AMENDMENTS TO THE DRAWINGS:

REPLACEMENT SHEET

FIG. 1

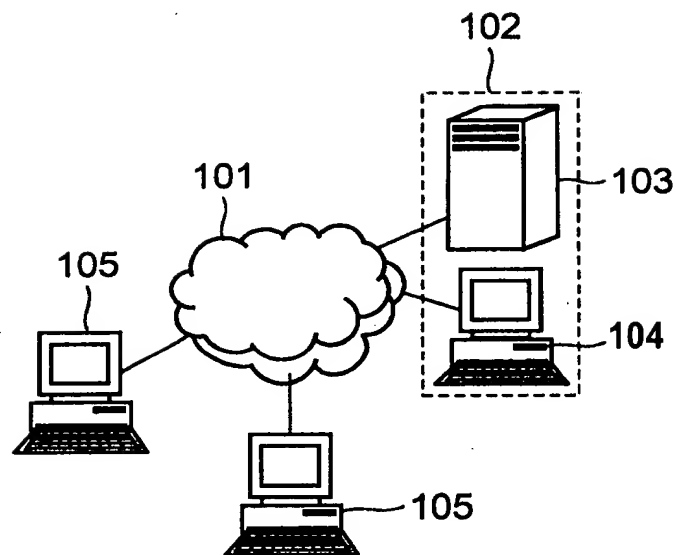
In FIG. 1, an agent terminal shown in the dealer system 102 was mislabeled "103." The agent terminal has been labeled "104," consistently with the Specification. FIG. 2 the dealer server was mislabeled as dealer server "105." The dealer server has been labeled "103," consistently with the Specification. Further, the main memory has been labeled "202," consistently with the Specification.
